Revision Notes:				
R1 - PINOUT TABLES UPDATED, CABLE BUILDUP UPDATED AS PER ECR CR-A289.				
APA: S.ATTWOOD	Drawn: R.BATES	Checked: B.CHILDS	Approved: G.PLITH	Date: 24/07/14

CHANGES FROM BASE PRODUCT BE-X003 (0805) TO AC-041 (4245)

Assembly Pl Approval J.FULLER - 12/06/13	Approved by G.PLITH	Checked by B.CHILDS	Drawn by M.POTTER
Angle of Projection	Units mm	Scale N/A	Released 13/06/13	Assembly Ref -
Third Angle	Status RELEASED	AC-041	
	Part No 4245	BE-002199-01-12

VIEW A

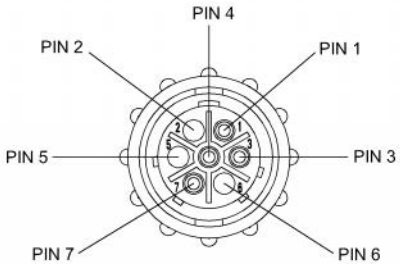
R1

PIN #	WIRE COLOUR	DESCRIPTION
1	RED	+12V
2	NOT USED	NOT USED
3	SHIELD	GND
4	YELLOW	VIDEO
5	NOT USED	NOT USED
6	NOT USED	NOT USED
7	SHIELD	GND

VIEW B

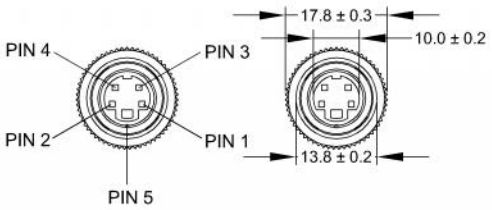
R1

PIN #	WIRE COLOUR	DESCRIPTION
1	YELLOW	VIDEO
2	RED	+12V
3	BLUE	ADD. FUNCTION
4	NOT USED	NOT USED
5	SHIELD	GND

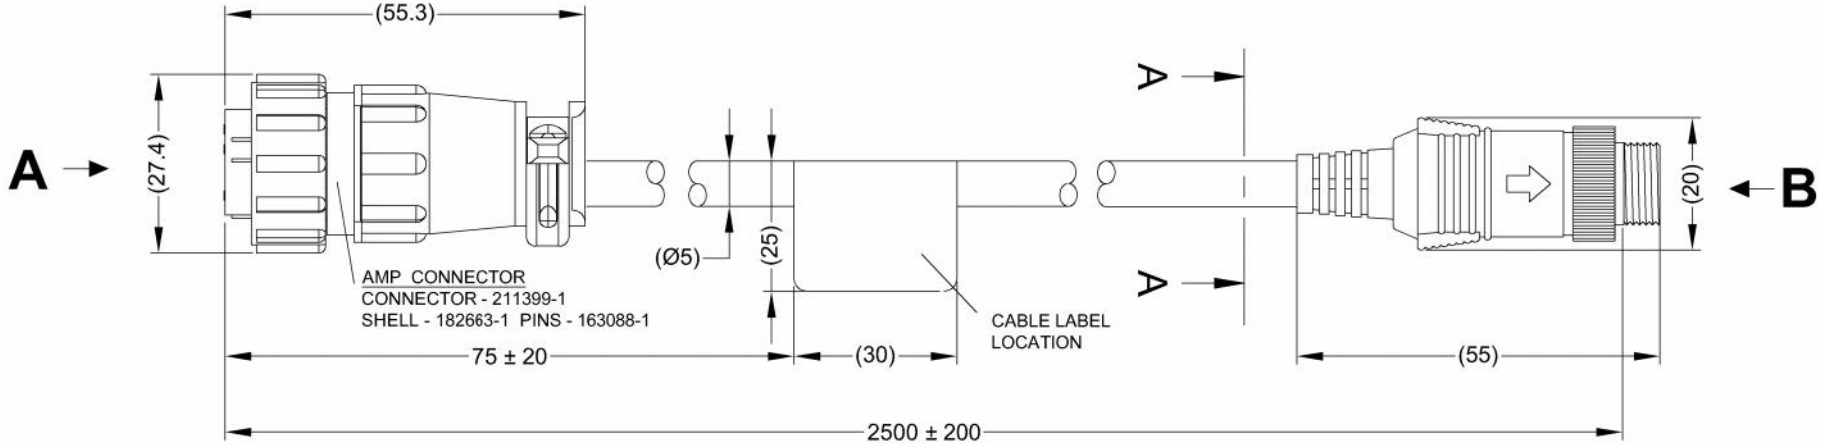
CHANGE:
1. CUT CABLE TO REQUIRED LENGTH.
2. REPLACE 4 PIN MALE CONNECTOR WITH 7 PIN FEMALE AMP CONNECTOR.
3. REPLACE BE-X003 (0805) CBL-LBL WITH AC-041 (4245) CBL-LBL..
4. REPLACE BE-X003 (0805) GB-LBL WITH AC-041 (4245) GB-LBL
